# Access Compliance Report

### (Curb Ramps)

Intersection ID: 10023914	Main Street: CONFERENCE_DR	Cross Street: N/A	Location: SW
ADA ID: DD9B3F270730	Ramp Type: Perp	Initial Pass/Fail: Fail	Overall Compliance: No
Severity Score: 12.5			
Codes/Mitigation Info/Possible Solution		Field Measurements/Component Compliance

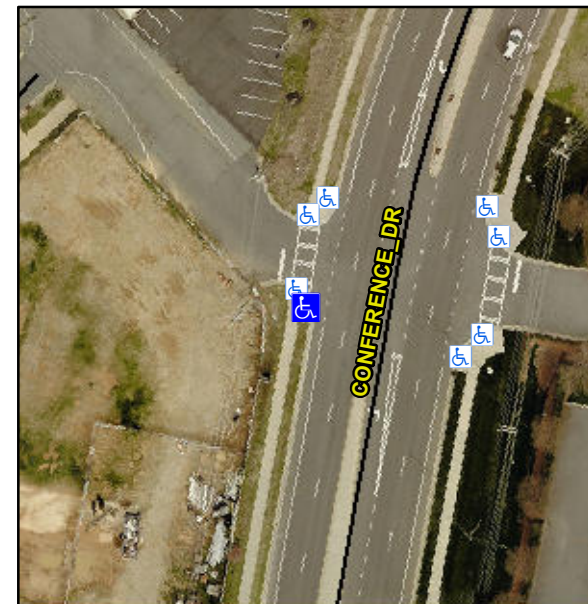
**R304.2.2**

Compliance	Description	Data	Compliance	Description	Data
N/A	Ramp Length (in)	64.0	No	Ramp Slope (%)	9.0
Yes	Ramp Width (in)	48.0	Yes	Ramp XSlope (%)	0.7
N/A	Flare Type LT	N/A	N/A	Flare Type RT	N/A
N/A	Flare Slope LT (%)	N/A	N/A	Flare Slope RT (%)	N/A
N/A	Flare Traversable LT?	N/A	N/A	Flare Traversable RT?	N/A
N/A	Landing Length (in)	N/A	N/A	DWS Provided?	N/A
N/A	Landing Width (in)	N/A	N/A	DWS Contrast?	N/A
N/A	Landing Slope (%)	N/A	N/A	DWS Length (in)	N/A
N/A	Landing X Slope (%)	N/A	N/A	DWS Full Width?	N/A
N/A	Landing Curb? (Y/N)	N/A	N/A	DWS Offset (in)	N/A
N/A	Shared Landing?	N/A			
N/A	Gutter Ponding?	N/A	N/A	Gutter Slope (%)	N/A
N/A	Gutter Lip Ht (in)	N/A	N/A	Gutter X Slope (%)	N/A
N/A	Painted X Walk1?	No	N/A	Painted X Walk2?	N/A
	X Walk 1 Direction	To SE		X Walk 2 Direction	N/A
N/A	X Walk 1 Width (in)	N/A	N/A	X Walk 2 Width (in)	N/A
	X Walk 1 Slope (%)	2.4		X Walk 2 Slope (%)	N/A
	X Walk 1 X Slope (%)	1.2		X Walk 2 X Slope (%)	N/A

**Remove & Replace Entire Ramp.**
